Working Party on the Transport of Perishable foodstuffs
(Sixty-second session,
Geneva, 6-9 November 2006)

**PROPOSAL FOR THE NUMBER OF TEMPERATURE
MEASURING POINTS**

Transmitted by the Government of Sweden

Fig. 1

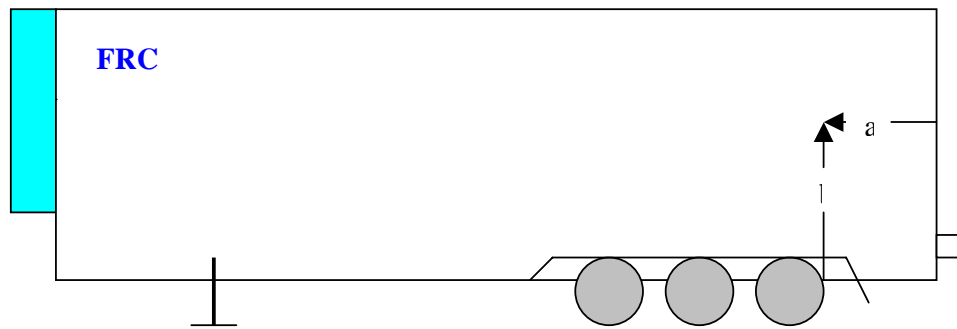
Temperature measuring instruments protected against radiation shall be placed inside and outside the body at the points specified below and fig.1.

For measuring the inside temperature of the body (T_i) the temperature measuring instrument shall be placed at a maximum of 50cm from the rear door and on half the height of the body.

For measuring the outside temperature of the body (T_e) the temperature measuring instrument shall be placed at least 10 cm from a outer wall of the body.
